Staff Report to the Planning Commission

Application Number: **07-0112**

Project Description: Proposal to divide an approximately 6.08 acre parcel into three parcels of 1.44, 1.34, and 3.30 acres and to construct three single family dwellings.

- **DENIAL** of Application 07-0112, based on the attached findings.

Profile - Common Driveway
 SCALE: 1" = 10'

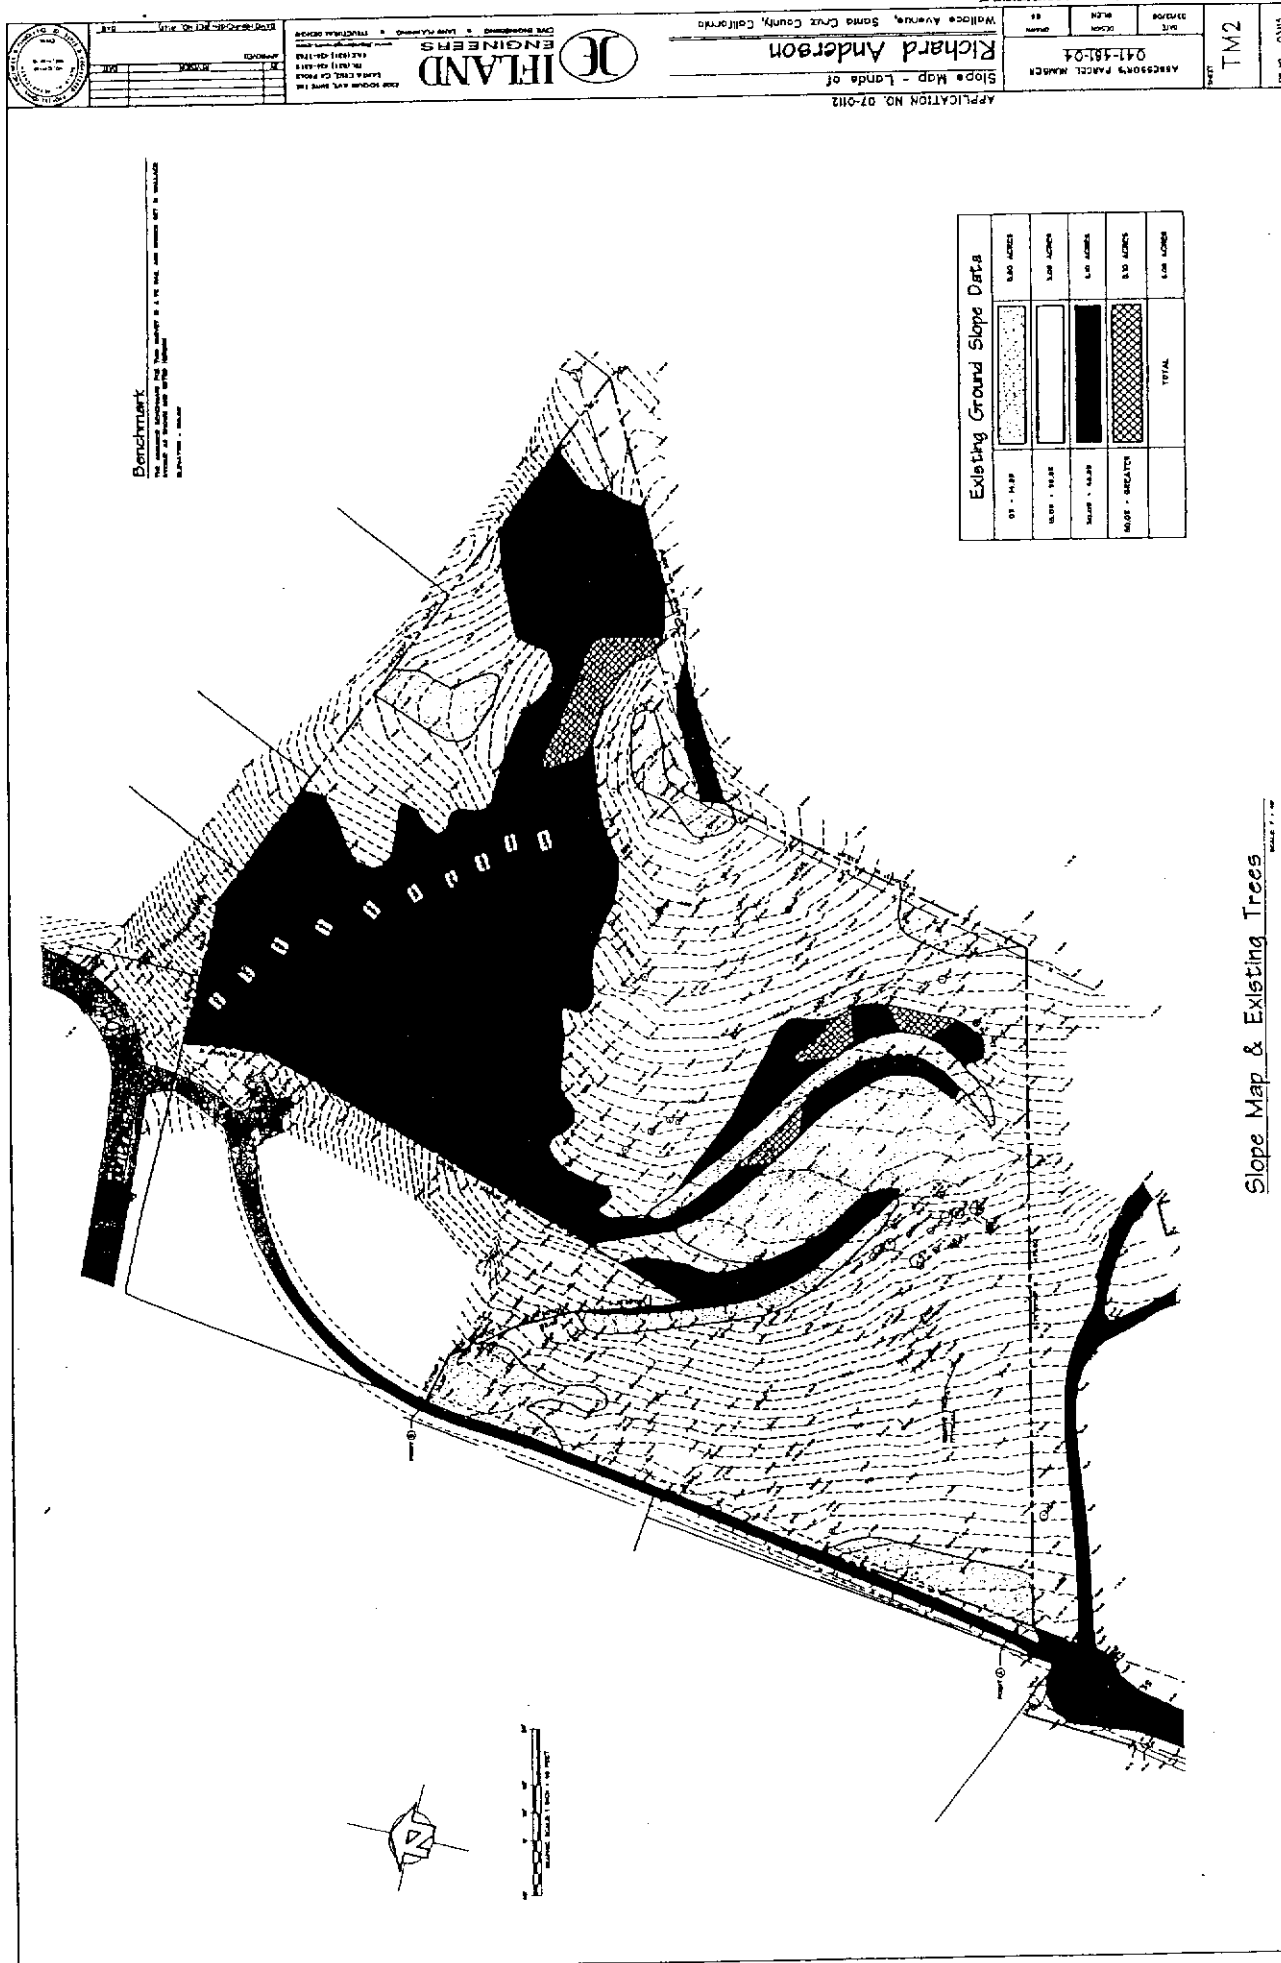
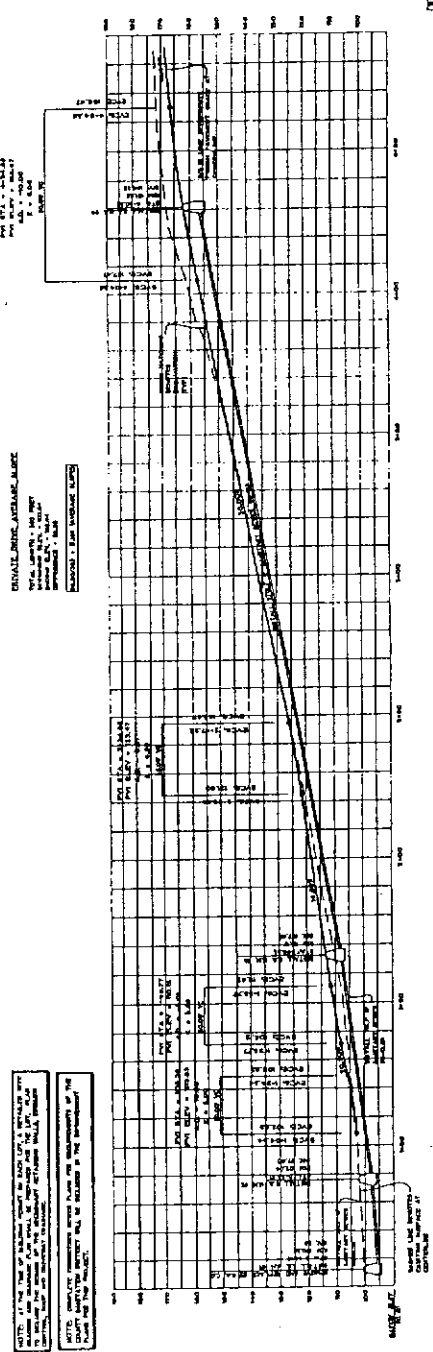
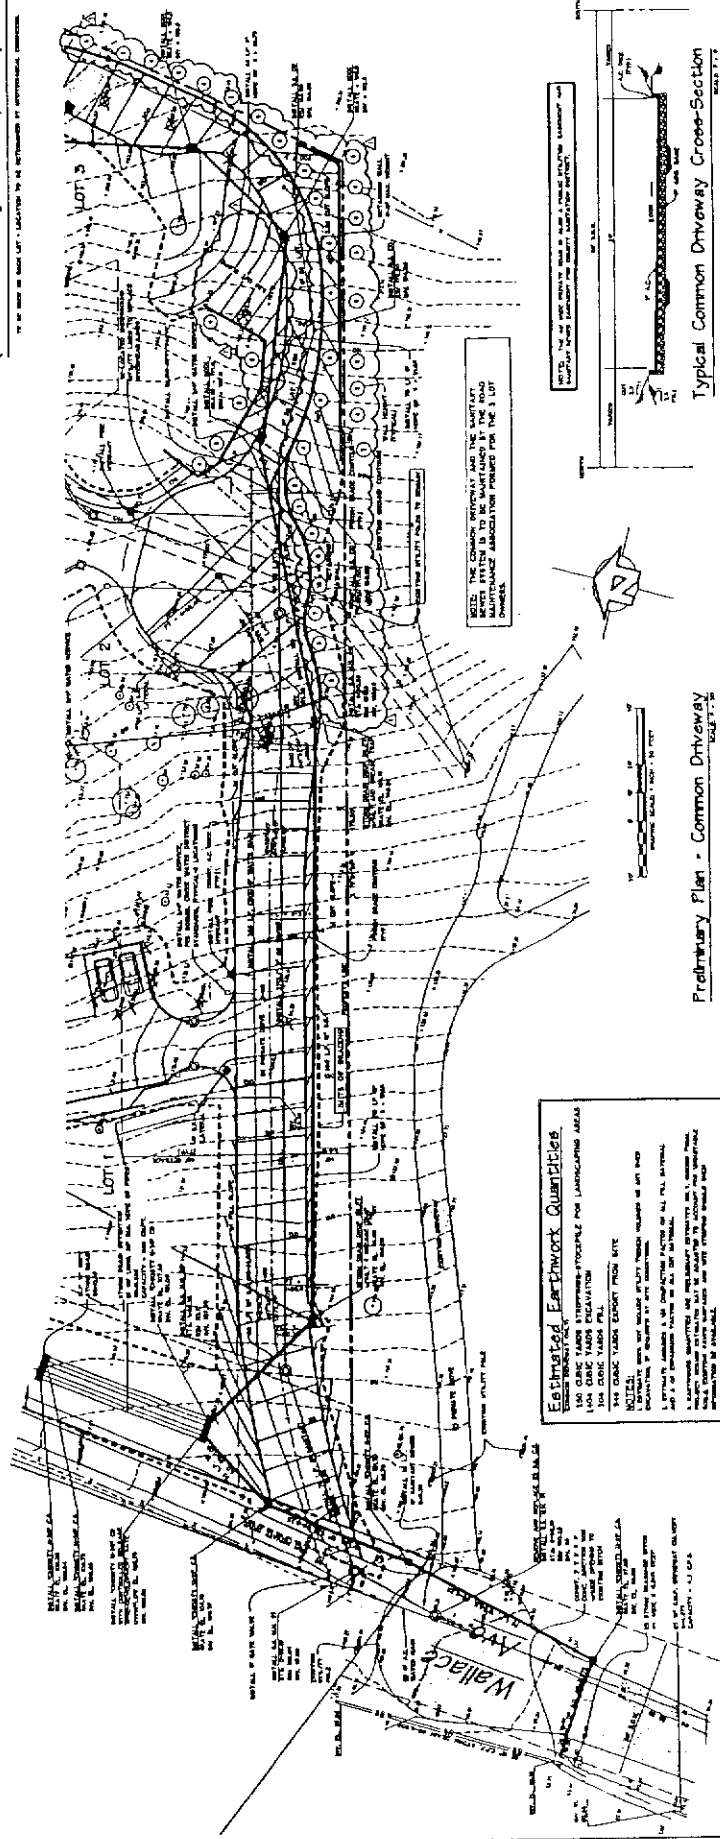
3) The proposed plan indicates the majority of runoff from proposed impervious areas will discharge to a pipe and open channel system along Wallace Avenue. Are the 12 inch pipe sections shown on sheet TM3 existing or proposed? Please demonstrate that this system is adequate to handle all existing and proposed runoff. Based on the results of the assessment this project may be required to upgrade downstream facilities and/or provide additional on-site mitigations.

6) It was not clear from the grading information provided on TM3 that only runoff from proposed impervious areas would be routed to the proposed detention facility per CDC requirements. Plans should clearly describe how open area runoff will be routed safely around the proposed detention pond. Contours shown on sheet TM3 indicate runoff may be routed into the detention facility.

- 2) It was not clear from the grading information provided on TM3 that only runoff from proposed impervious areas would be routed to the proposed detention facility per CDC requirements. Plans should clearly describe how open area runoff will be routed safely around the proposed detention facilities (the detention system should be located -off-line-). Contours shown on sheet TM3 indicate open area runoff may be routed into the detention facility.

LANDSCAPE PLAN - NOTES

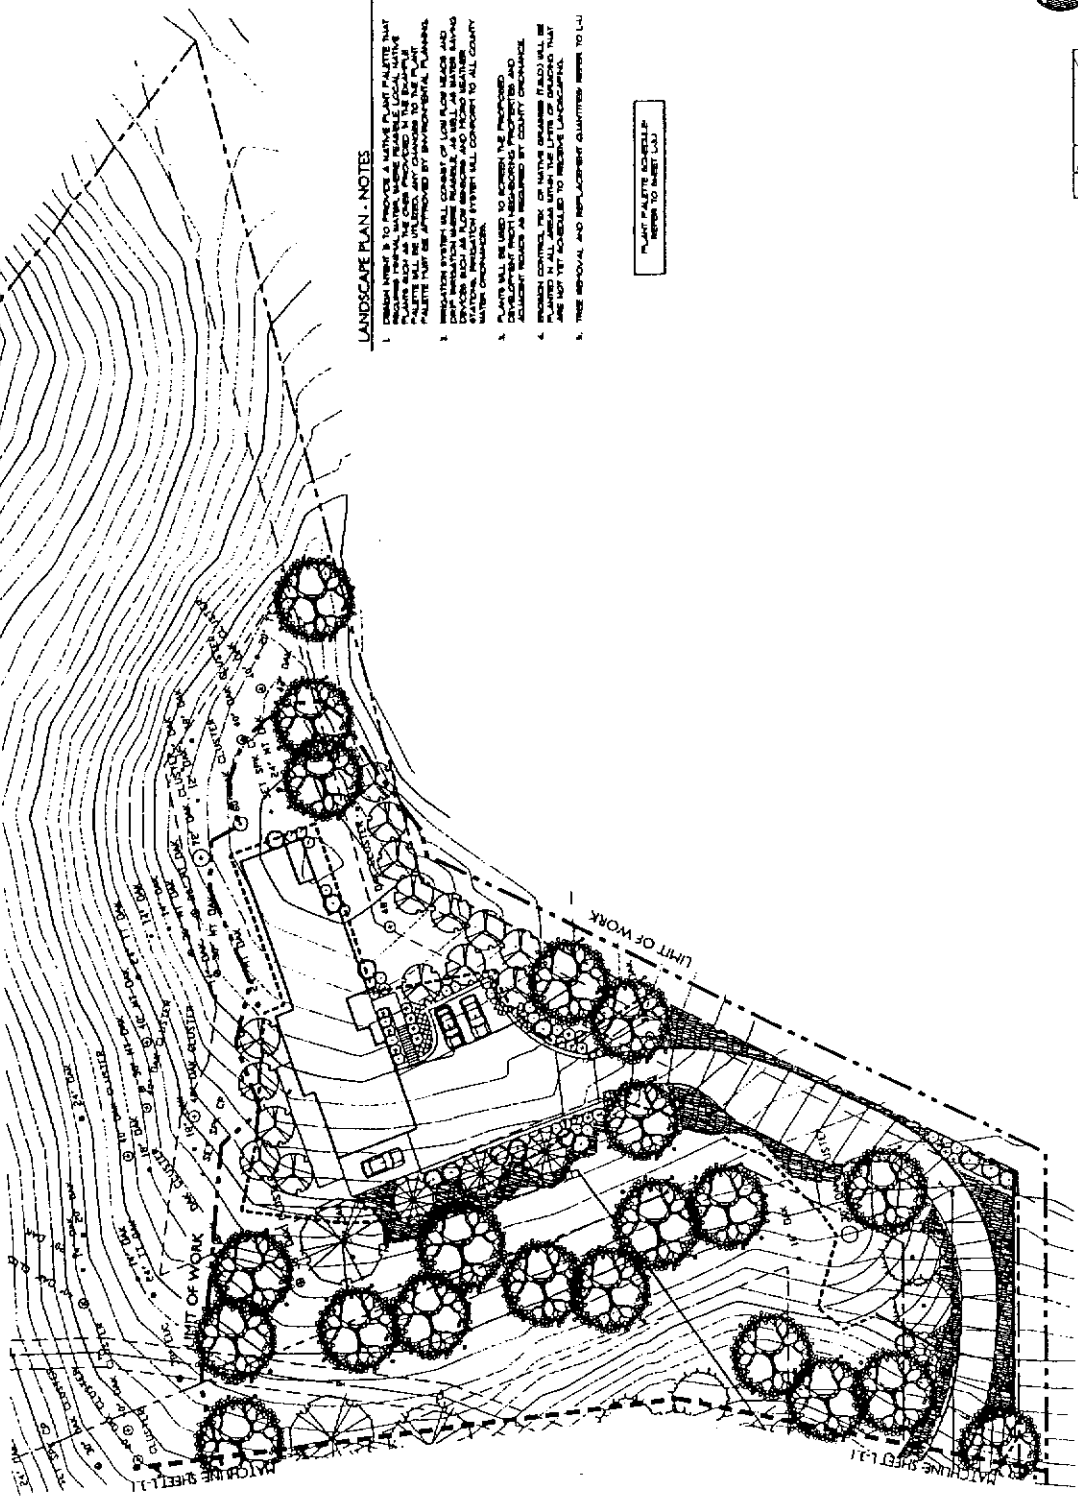
6. The 60" oak cluster within the right of way on lot 3 shown to remain on sheet L1.2 is not shown on sheet L3.2.

Although it is foreseeable that minor changes to the landscape plan may be necessary, any changes to the plant palette must be approved by Environmental Planning. Note 1 on sheet L3.2 should be revised to reflect this requirement or deleted.
